PLANS AND DOCUMENTS
referred to in the PDA
DEVELOPMENT APPROVAL

Approval no: DEV2025/NSH/4175

RE: Minor Change Application – 19 Hercules Street, Hamilton

This letter outlines a review by Colliers (previously TTM) of the revised project documentation in relation to a minor change application and the impact of the revised documentation on the currently approved environmental noise assessment report and development approval conditions.

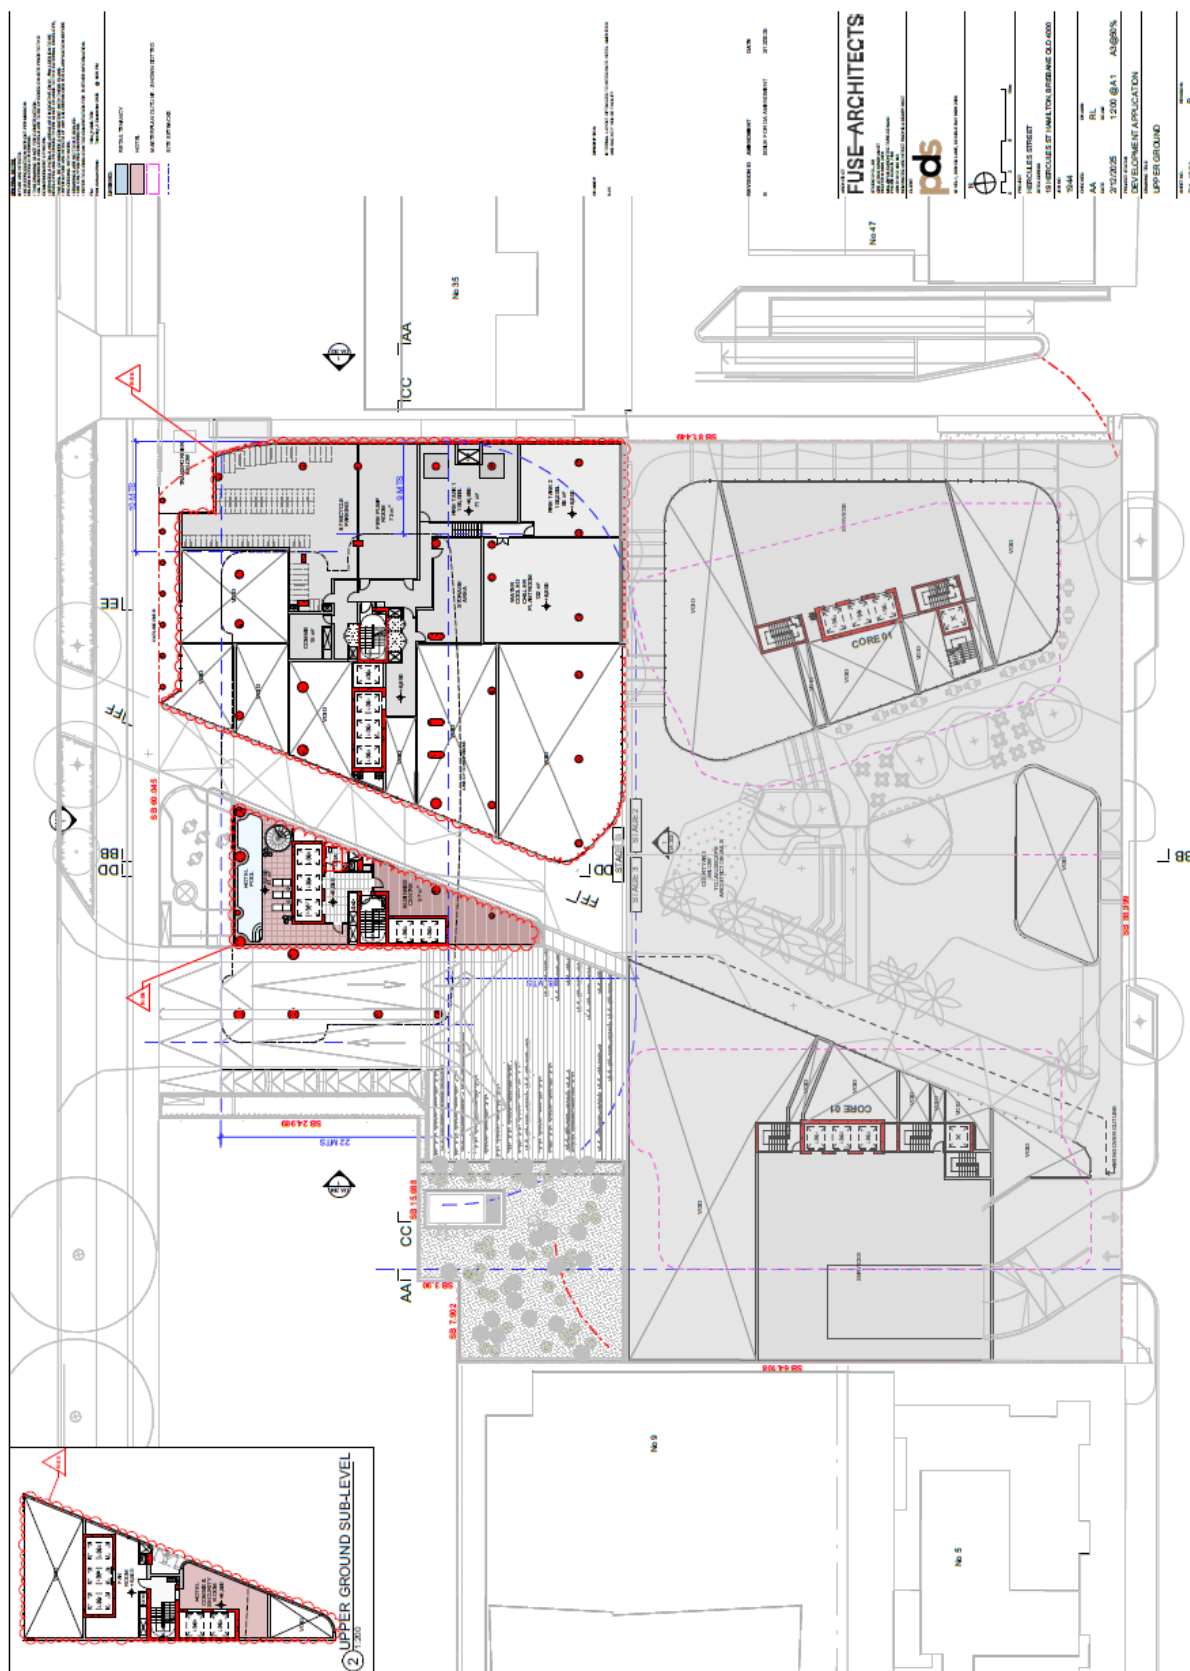
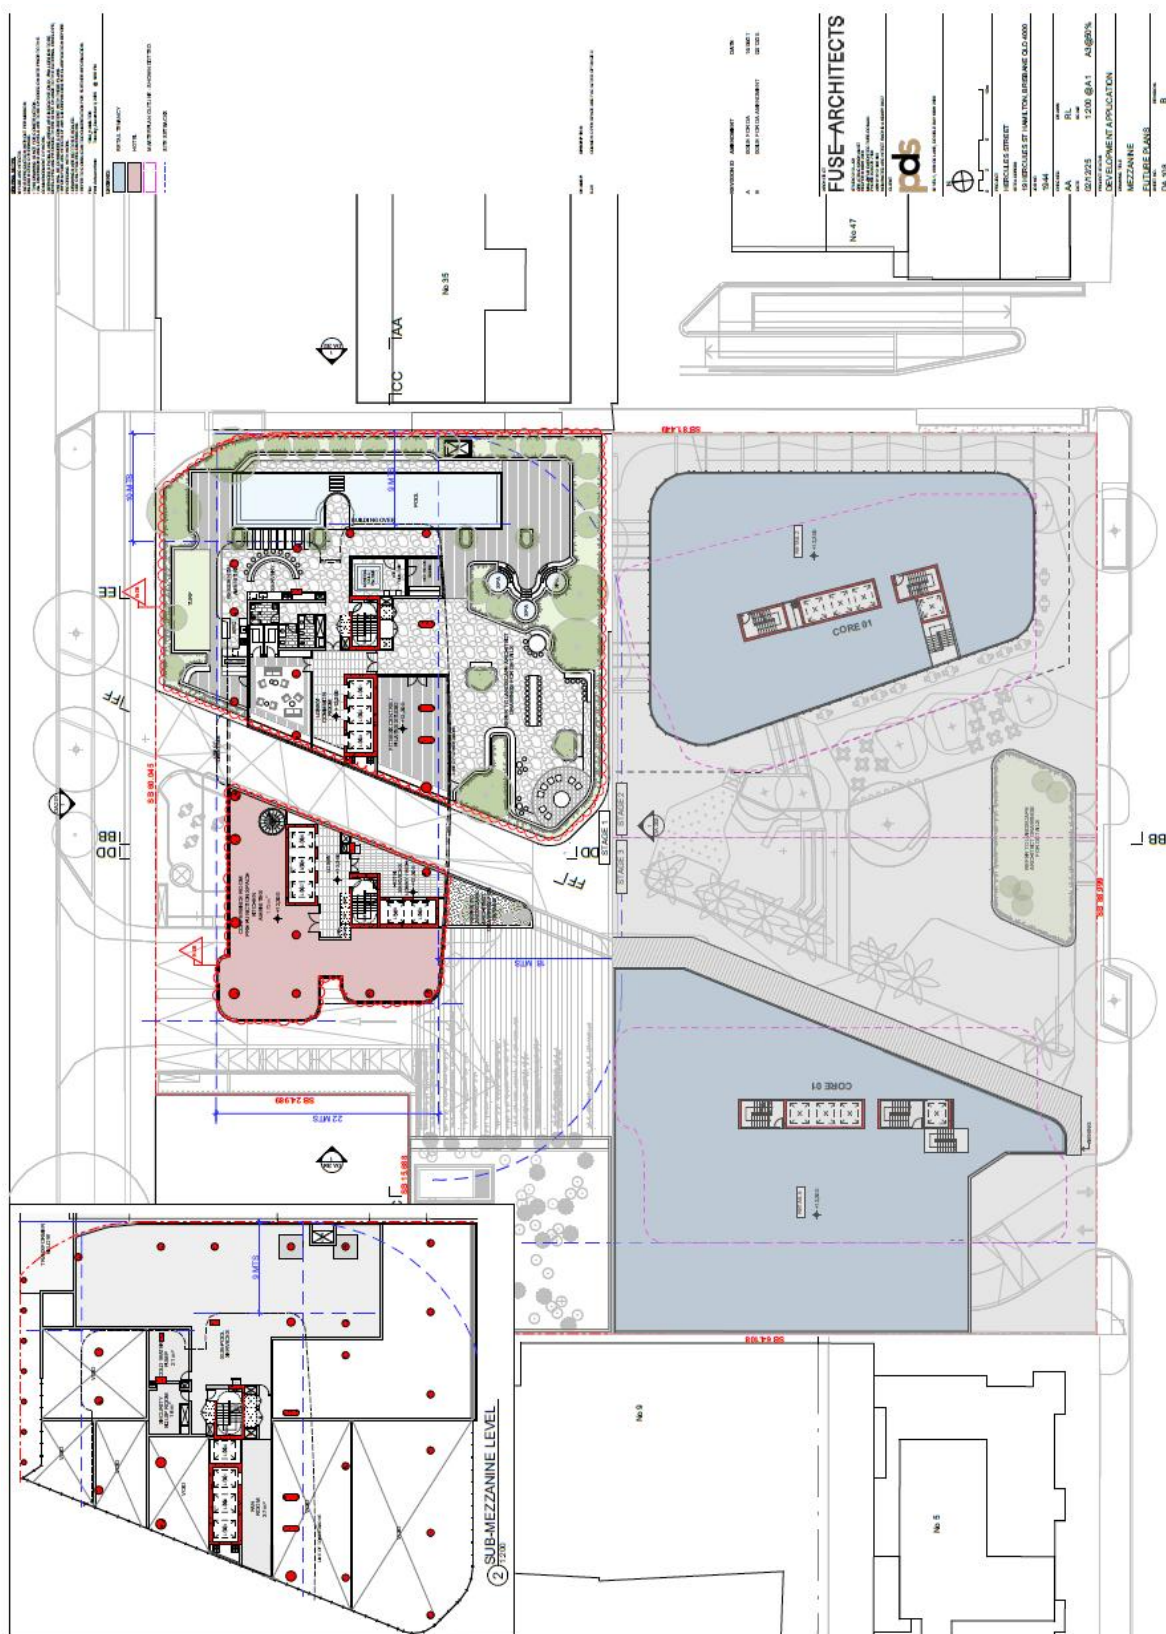
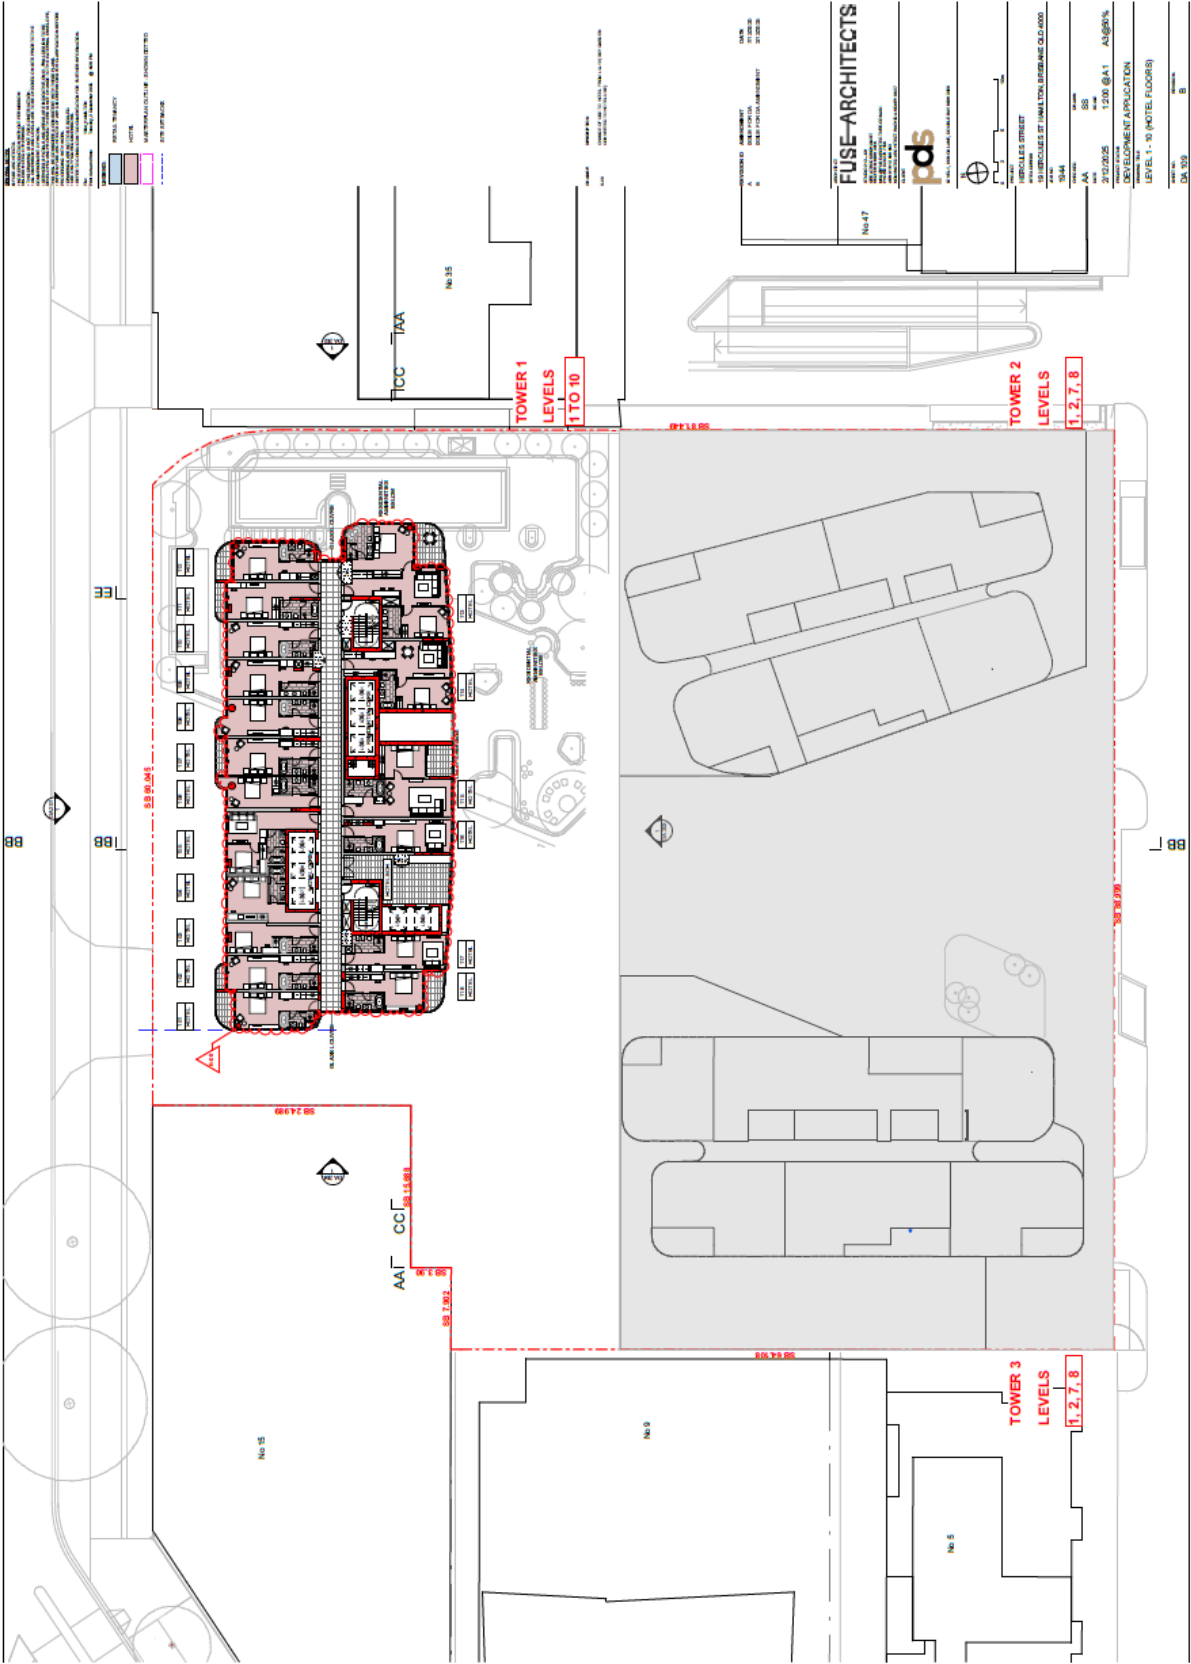
A review of the revised architectural plans was conducted and the plans were determined to be consistent with the assessment and recommendations of the approved ENA report with the exception of aircraft noise.

The current City Plan 2014 planning scheme Airport Environs overlay mapping does not located the site within an aircraft noise ANEF zone. Therefore, Sections 7 and 8.1 of the approved ENA report are now not applicable. The other recommendations of Section 8 remain applicable.

One additional, general recommendation is as follows:

- The conference room external facades and pre-function space west façade on the mezzanine level to achieve a minimum acoustic rating of Rw35.

Hence the EDQ development approval condition MCU 34 can be adjusted as follows:

a) Construct the approved development to include the acoustic treatments specified in ~~Section 8~~ Section 8.2 and 8.3 of the following approved document:
